W3F1-2004-0086

SUBJECT: Supplement to Amendment Request NPF-38-249,
Extended Power Uprate
Waterford Steam Electric Station, Unit 3
Docket No. 50-382
License No. NPF-38

Response to Request for Additional Information

Figure B-12 Pressurizer Temperature Deviation for Loss of Flow Transient

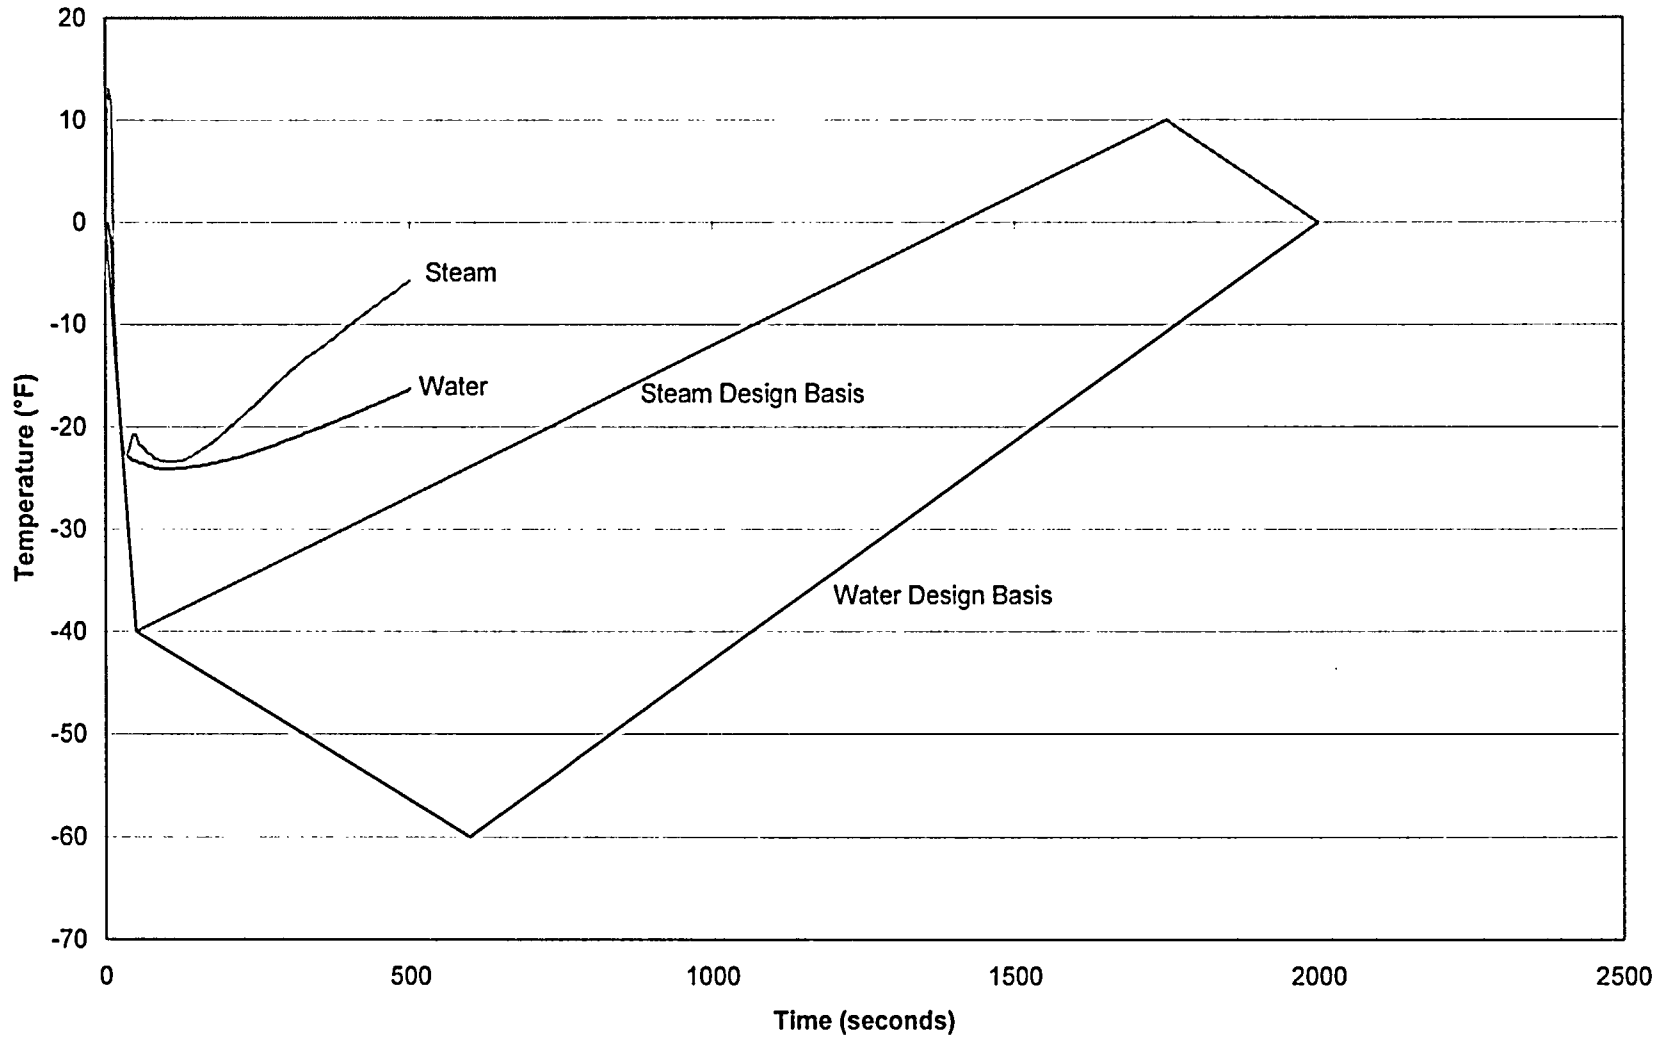
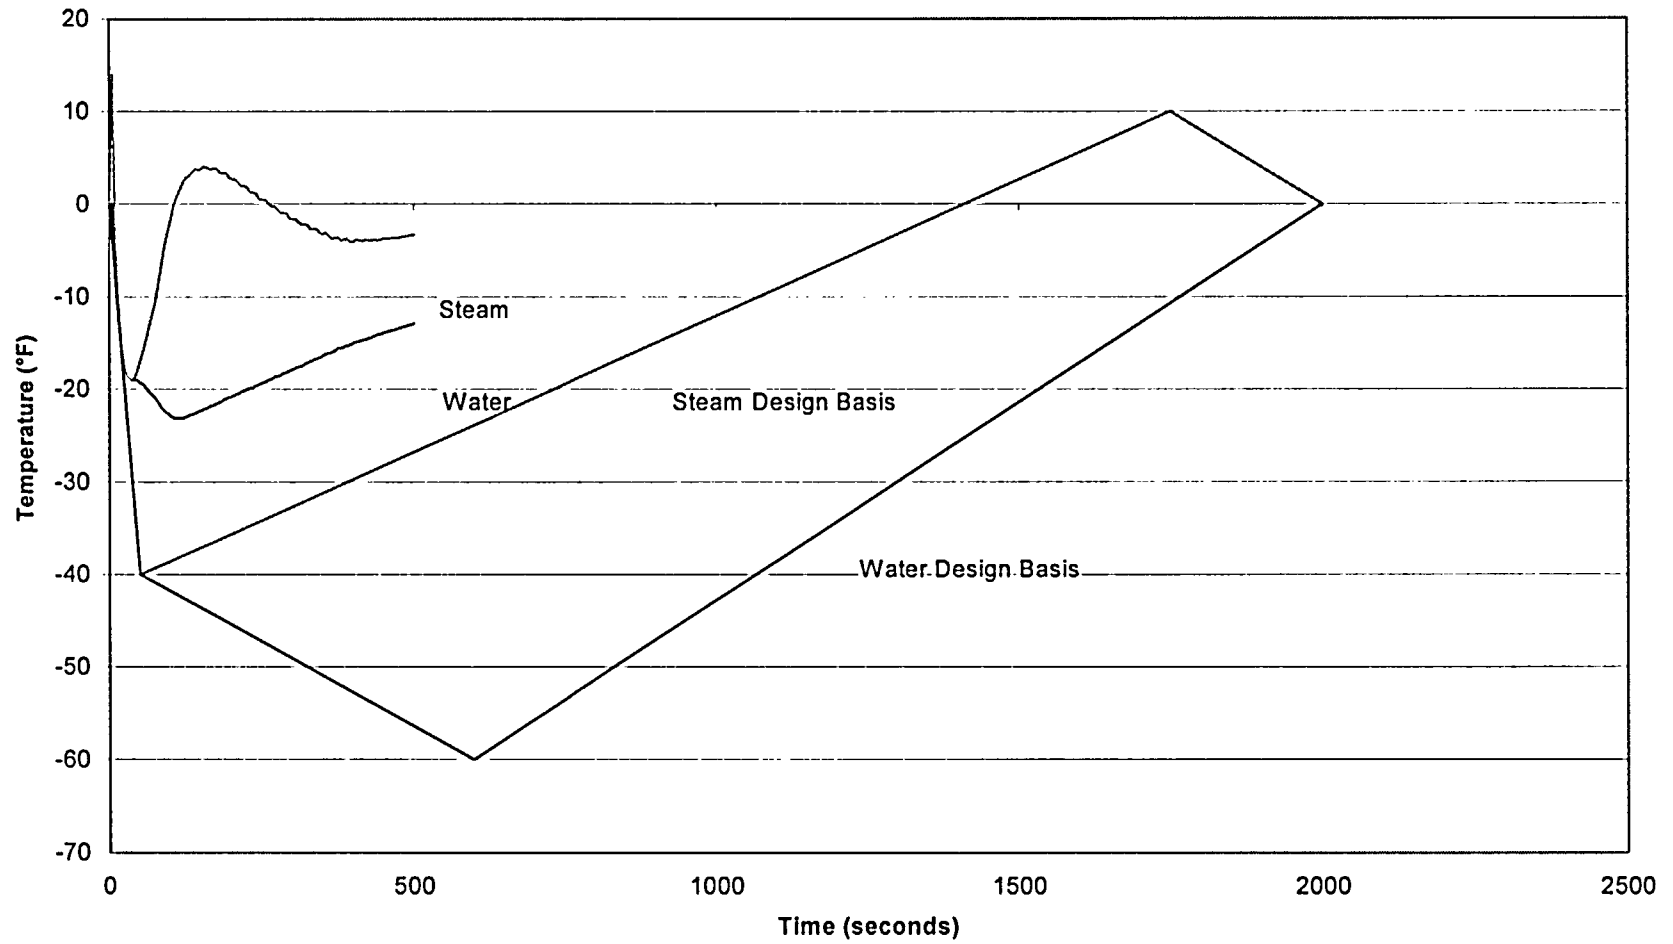
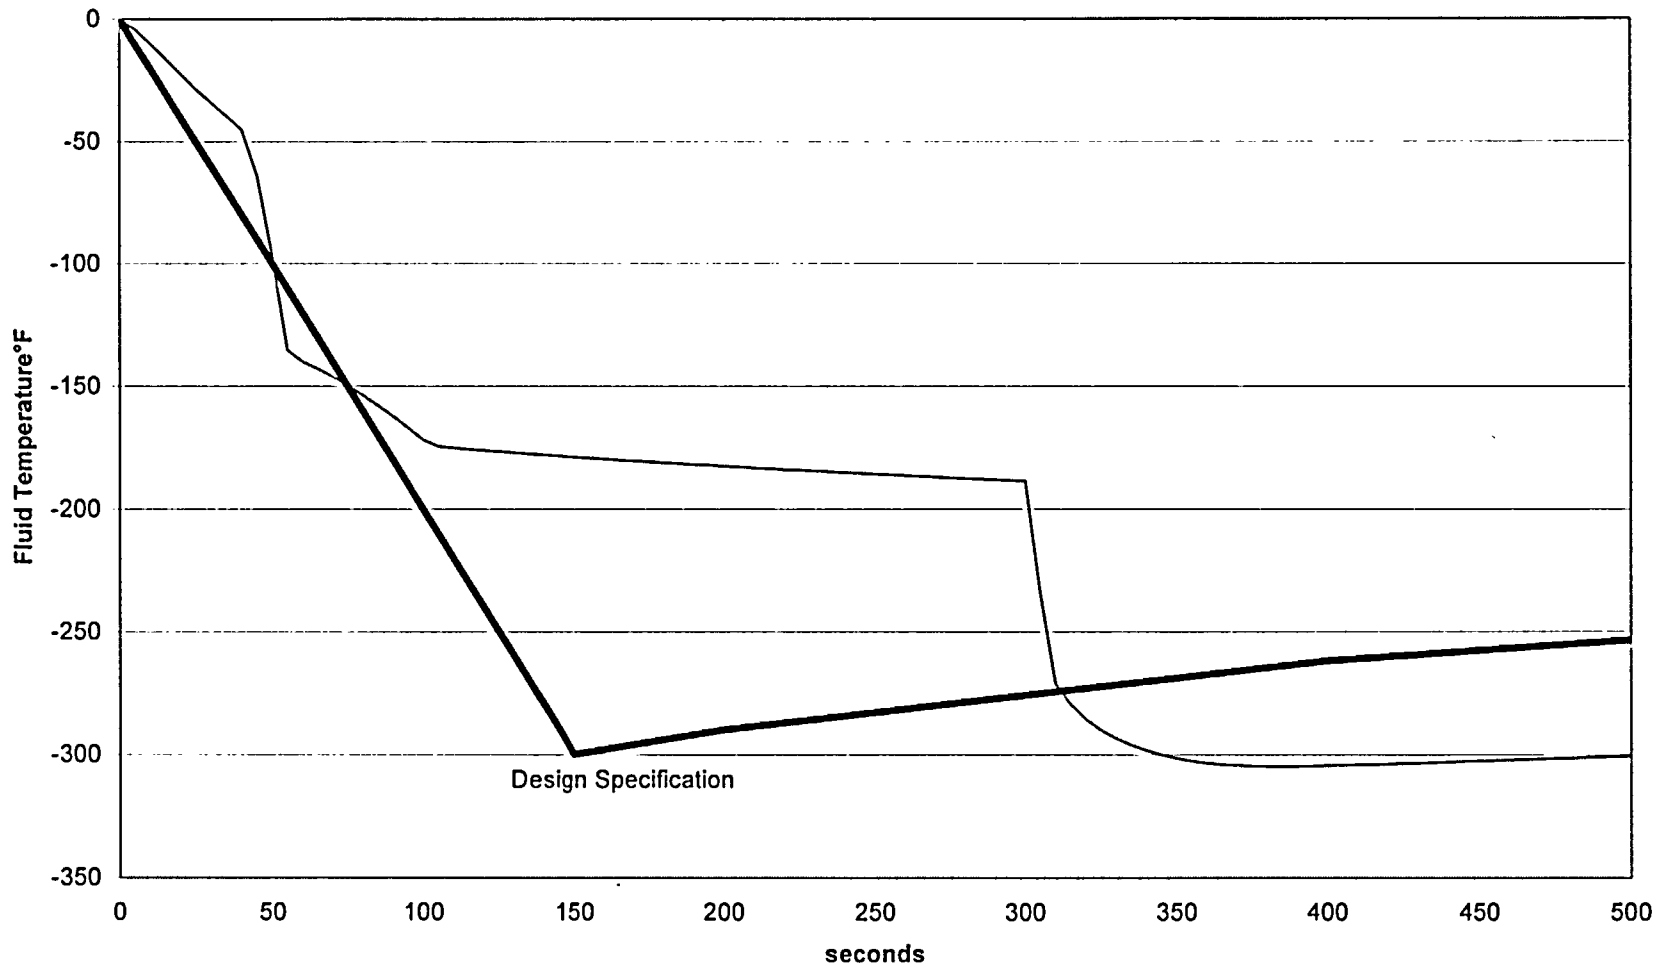
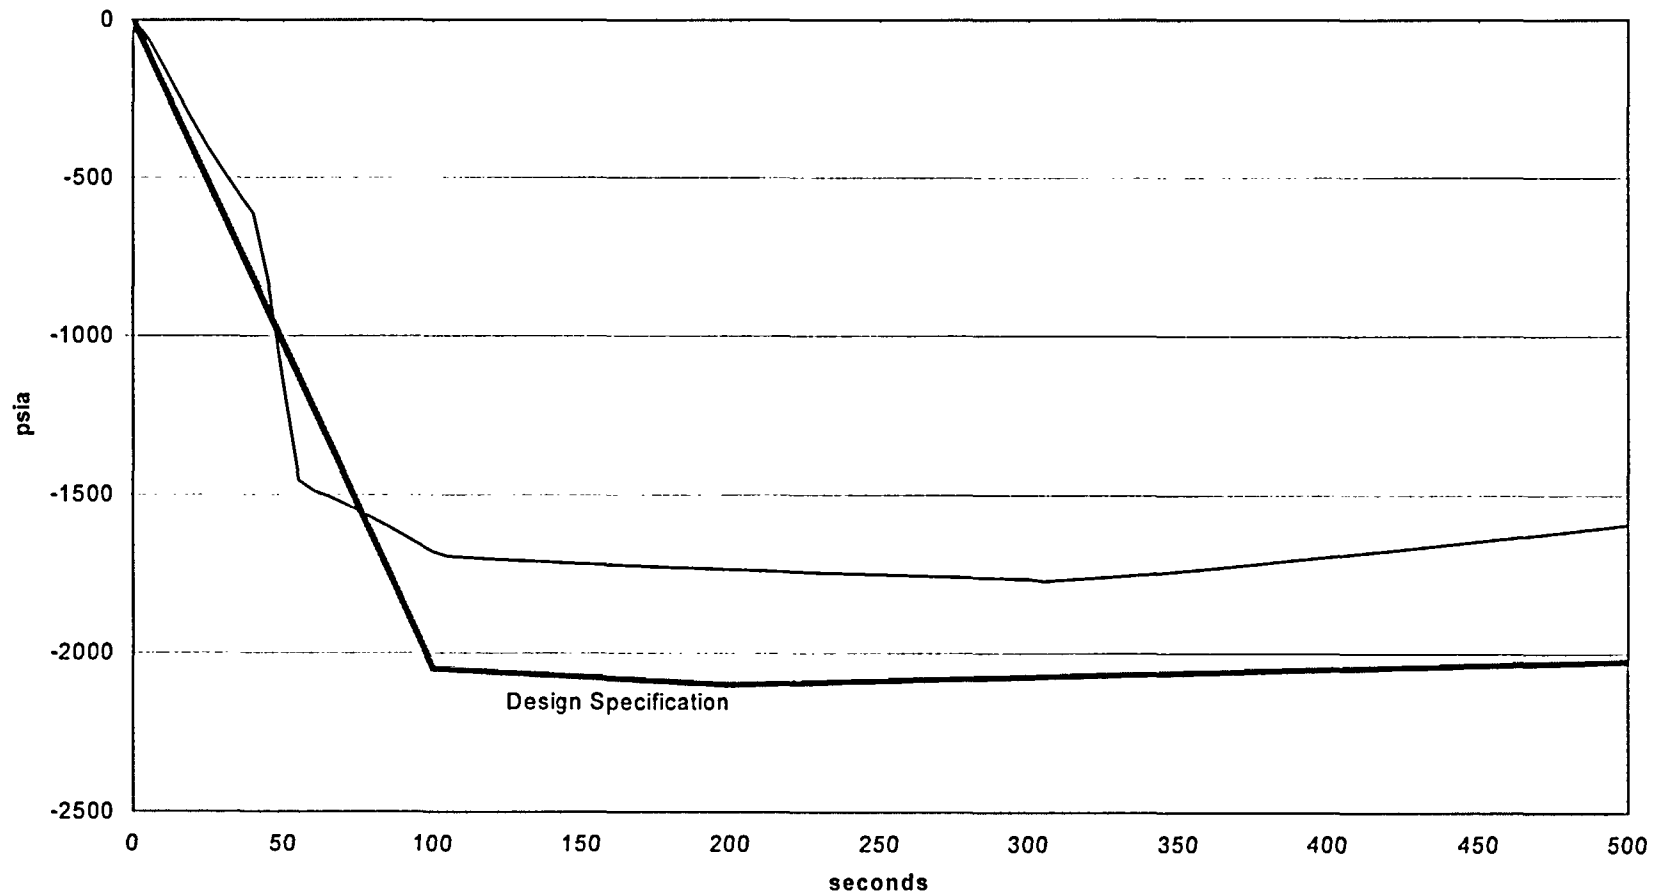
In Section 2.2.2.1.1, you indicated that power uprate resulted in minor changes to as-calculated normal operation transients, and a detailed evaluation of the changes in stresses and fatigue levels in the Reactor Coolant System (RCS) due to these transients was performed to demonstrate that the originally specified design transients for Waterford 3 remain applicable under Extended Power Uprate (EPU) conditions. This was accomplished by demonstrating that transients affected by EPU have no significant effect on the stresses or cumulative usage factors (CUFs) of the limiting RCS components. Provide a comparison of transients at the power uprate conditions to the original design-basis transients with respect to the number of occurrences and changes in pressure and temperature in the stress and cumulative fatigue usage calculations.

The originally specified design transients were evaluated for the potential effect EPU would have on them. The same list of events and number of event cycles were maintained for the EPU design transient evaluation. The Reactor Trip, Loss of Load, Loss of Flow and Loss of Secondary Pressure events were rerun using EPU conditions. The plots for the rerun cases are attached. The rerun cases and results of the evaluation were documented and evaluated for any effects on stress and fatigue levels.
